**TOWN OF HUDSON**  
**PLANNING BOARD**  
**PUBLIC MEETING**  
**TOWN OF HUDSON, NH**  
**MARCH 25, 2015**

# Cobblestone Village Older Persons Housing Development Site Plan Review

## Staff Report

**PLAN UNDER REVIEW ENTITLED:** "Residential Site Plan Cobblestone Village 137 Belknap Rd, Map 184; Lot 27, Hudson, NH, prepared by Keach-Nordstrom Associates, Inc., dated: Jan. 23, 2015, latest revision date March 5, 2015, consisting of Sheets 1 - 28 and Notes 1 - 37 on Sheet 1 of 28 (plan attached hereto).

DATE: JANUARY 23, 2015  
 PROJECT NO: 14-0721-1  
 SCALE: 1" = 80'  
 SHEET 1 OF 28

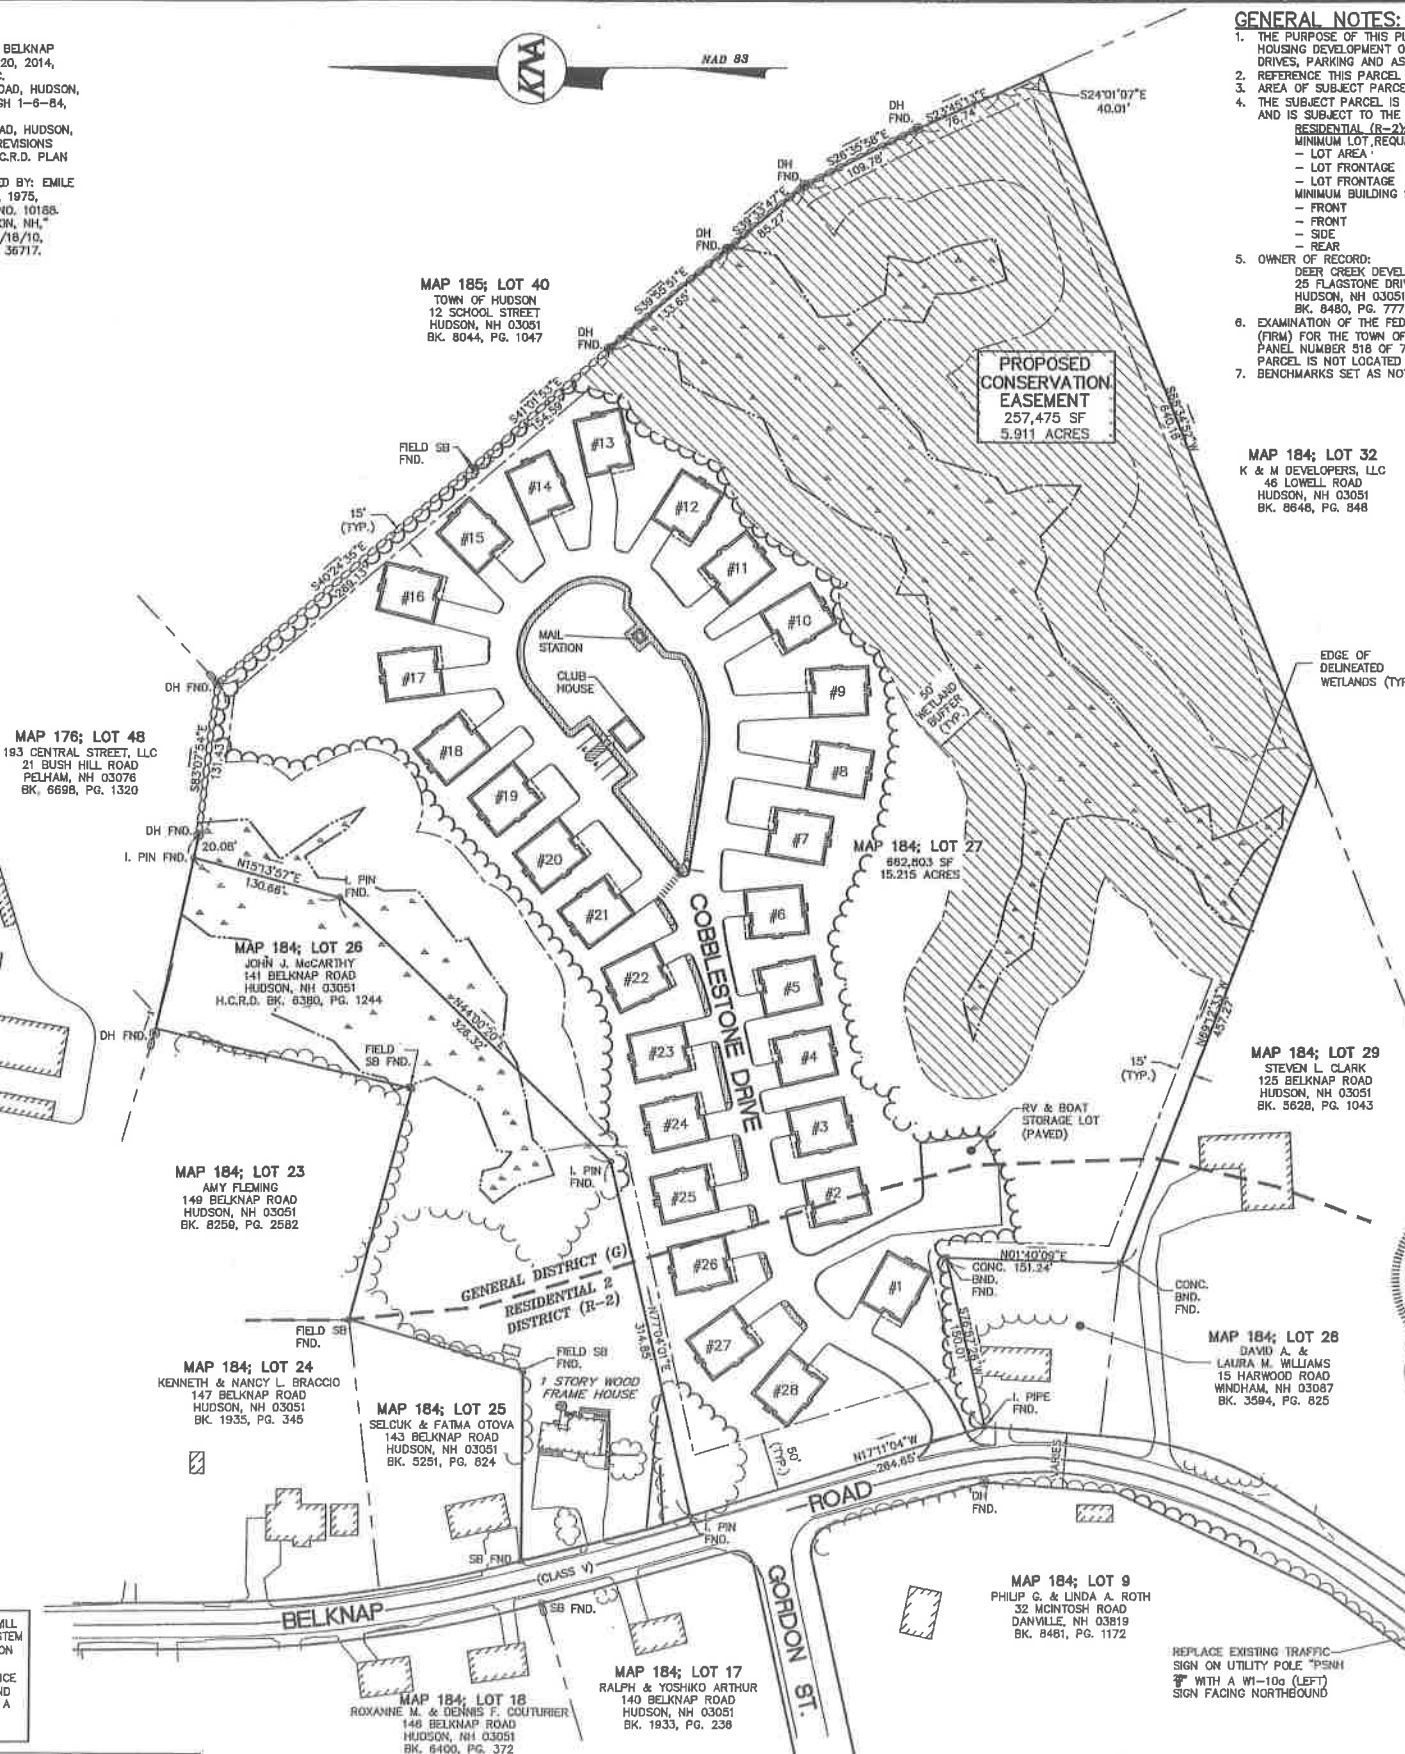
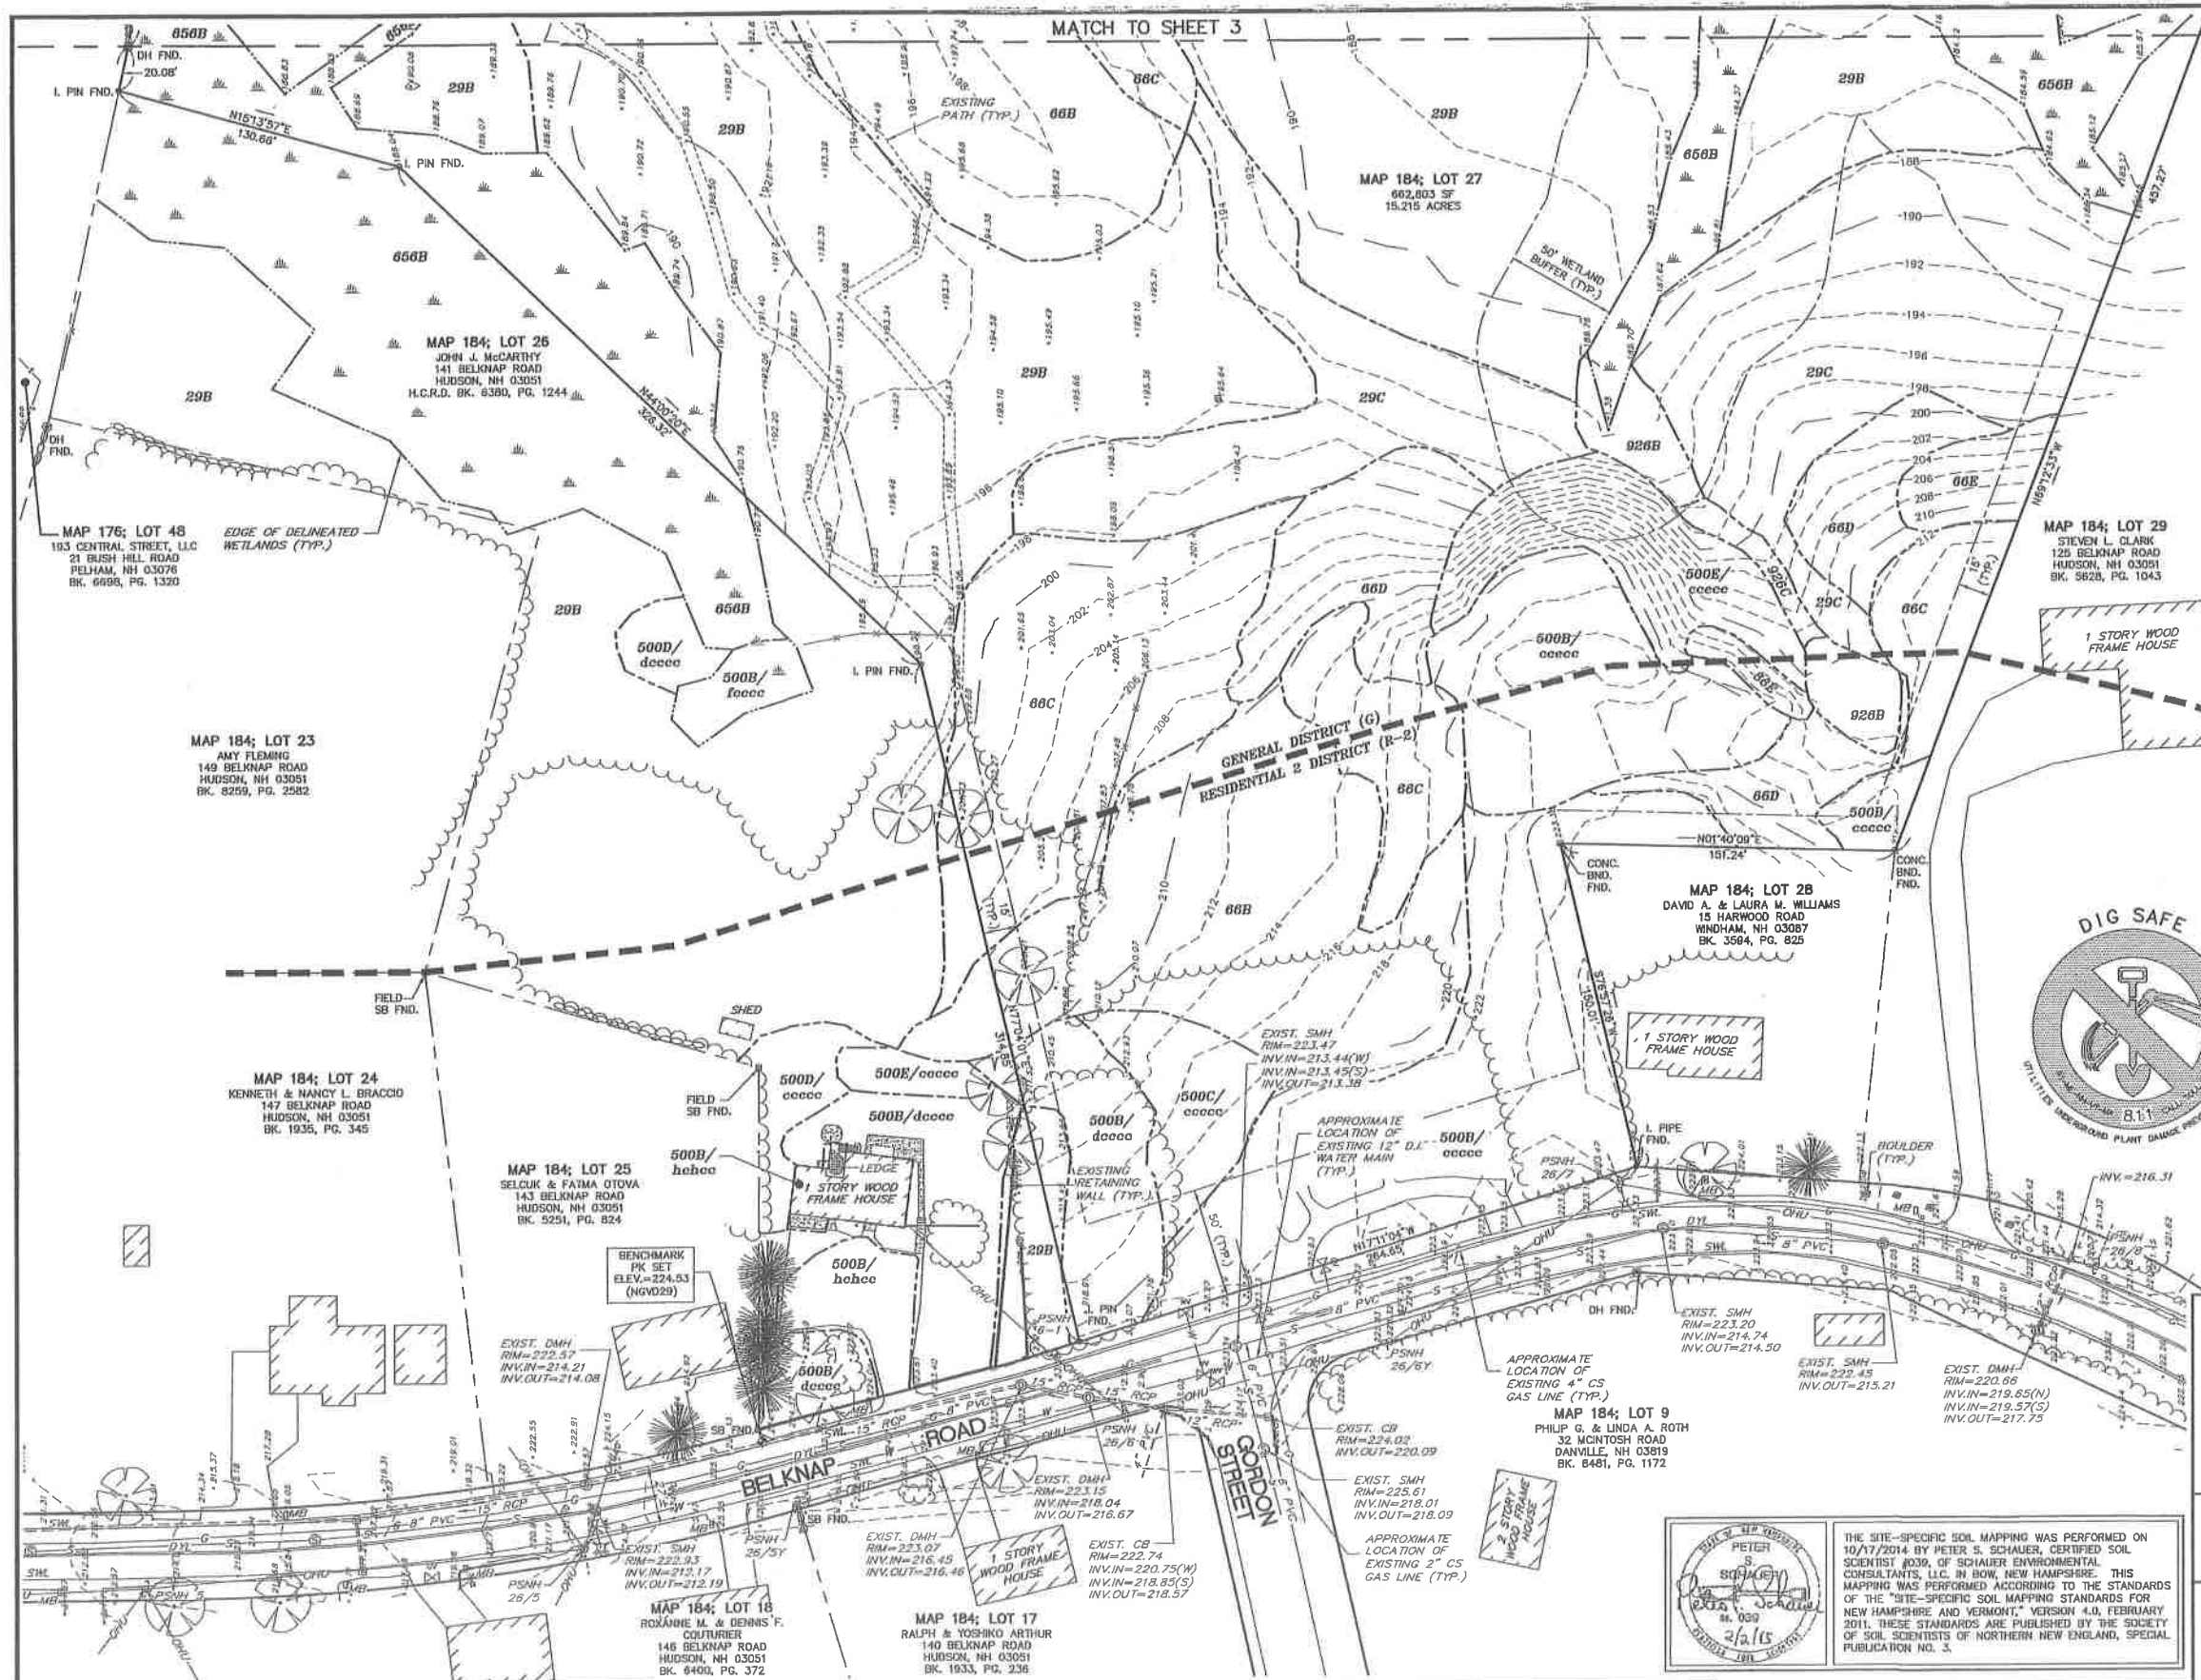
- d) One private cul-de-sac road, looped, connecting to Belknap, 840 ft. in-length.
2. The School Impact Fee doesn't apply to the Cobblestone Village 55+ Older Persons Housing Development, i.e., even though it is provided in Note 22 of Sheet 1. This is in accordance with the 2013 Planning Board action regarding the Sparkling River 55+ Older Persons Housing Development: the collection of the subject School Impact Fee does not meet the rational nexus provision set forth in RSA 674:21.V. To the effect of the foregoing, said Note 22 will have to be amended by deleting reference to the School Impact Fee.

8. Note 36 on Sheet 1 states that refuse removal will be provided, via private, curbside pickup. **Status:** in Hudson, for developments such as this, the Town typically provides curbside pickup of refuse. This item can be discussed at the hearing.

5. Prior to Planning Board endorsement of the Plan, Note 22 on Sheet 1 of 28 shall be amended by deleting reference to the School Impact Fee, which, because this Plan is exclusive to a 55+ older persons housing development, does not apply.

*Trash shall be collected via private, curb side trash pickup service. Note #36 was added to sheet 1.*

3. Revise the following notes:  
A. Sheet 1 /28, note 20. Add: This road shall remain private after construction.

*Revised as requested in note 37 on sheet 1.*

DATE: JANUARY 23, 2015      SCALE: 1" = 40'  
 PROJECT NO: 14-0721-1      SHEET 13 OF 28

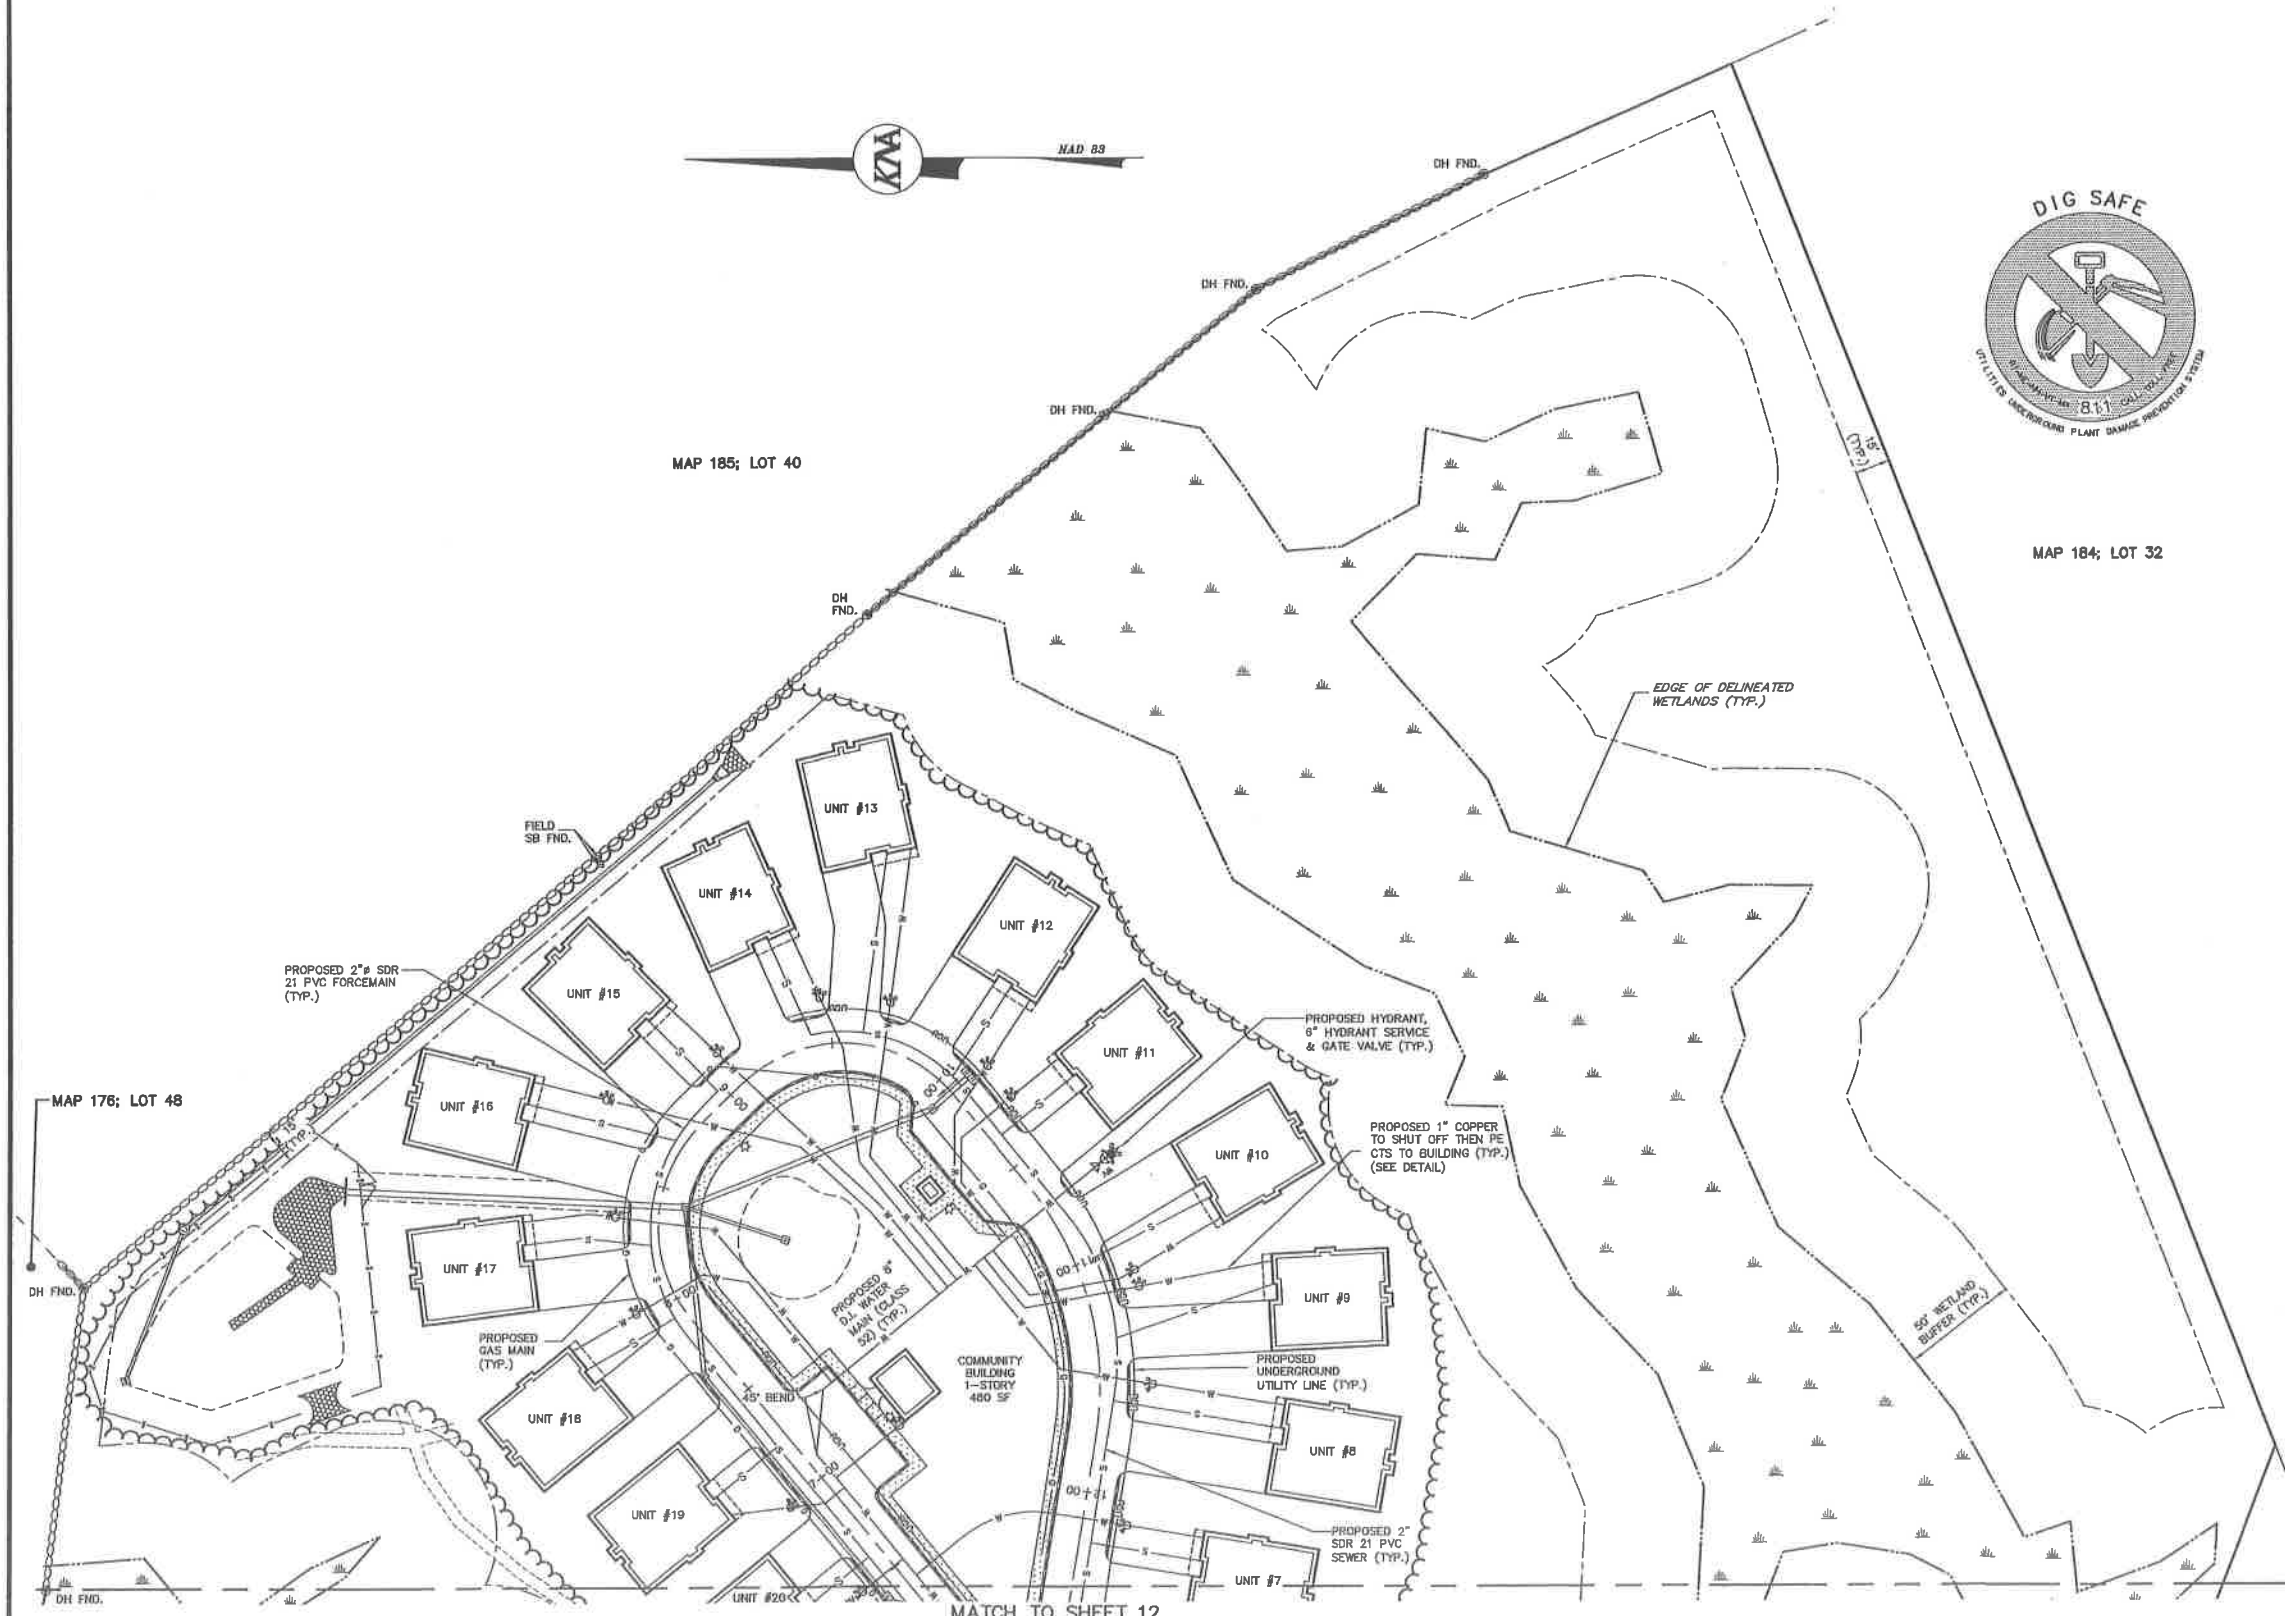
**Current CLD Comment:** The applicant has revised the size of the proposed pipe to 3-inch SDR 21 PVC but there are still plan note references to 2" pipe on sheet 13 that should be updated.

- k. *Former CLD Comment: The applicant should review the design of the water main on Sheet 13. The applicant should provide documentation demonstrating that routing it under a mini-detention pond to a dead-end hydrant will not result in freezing of the water main or other potential future problems. If this configuration remains, the applicant should provide a profile for this section of water.*

- n. *Former CLD Comment: The applicant has not shown water shutoffs for any buildings on Sheet 13.*

- k. The applicant should review the design of the water main on sheet 13. The applicant should provide documentation demonstrating that routing it under a mini-detention pond to a dead-end hydrant will not result in freezing of that water main or other potential future problems. If this configuration remains, the applicant should provide a profile for this section of water.

- n. The applicant has not shown water shut-offs for any buildings on Sheet 13.

Current CLD Comment: The applicant has added water shutoffs for all buildings on Sheet 13. No further CLD comment.
